MIL-B-5087B(ASG)
Amendment 2
31 August 1970
Superseding
Amendment 1
6 February 1968

MILITARY SPECIFICATION

BONDING, ELECTRICAL, AND LIGHTNING PROTECTION, FOR AEROSPACE SYSTEMS

This amendment forms a part of Military Specification MIL-B-5087B(ASG), 15 October 1964, and has been approved by the Department of the Air Force and by the Naval Air Systems Command.

FIGURE 6. Fault current (Amperes)

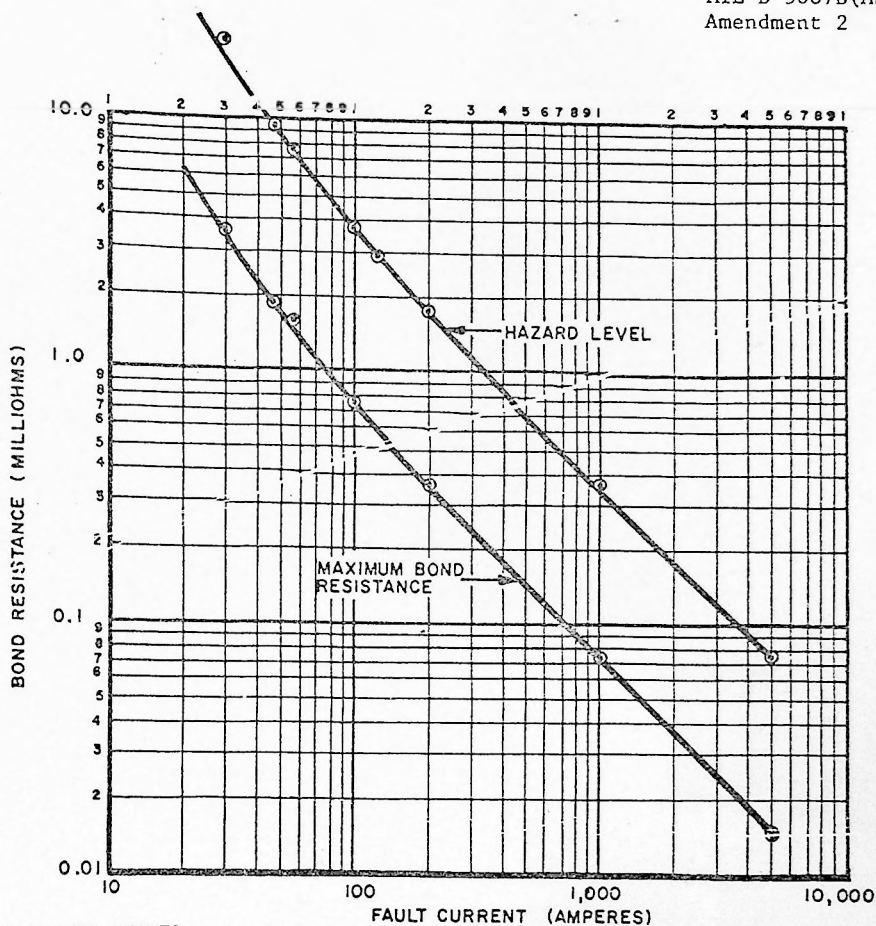
"3.3.2.4 Bonding in hazard areas. In areas prone to explosion or fire hazards, the resistance between the equipment case and structure shall not exceed the values shown on figure 6. The fault current shown is the maximum current that the electrical system is capable of delivering to the fault in the event that an internal power-to-ground fault takes place and high current passes through the equipment housing to structure. Since bonding in itself cannot eliminate all possible sources of ignition, the equipment shall be designed to minimize hot spots, sparking, and expulsion of molten metal when an internal power fault occurs.

Page 13, figure 6: Delete and substitute the attached figure 6. Figure 6 forms page 3 of this amendment.

NOTE 1. DATA POINTS

AMPS	HAZARD RESISTANCE (MILLIOHMS)	MAX RESISTANCE (MILLIOHMS)
5000	0.074	0.0148
1000	0.37	0.074
200	1.85	0.37
120	2.83	—
100	3.7	0.74
58	7.7	1.54
49	9.3	1.86
30	18	3.6
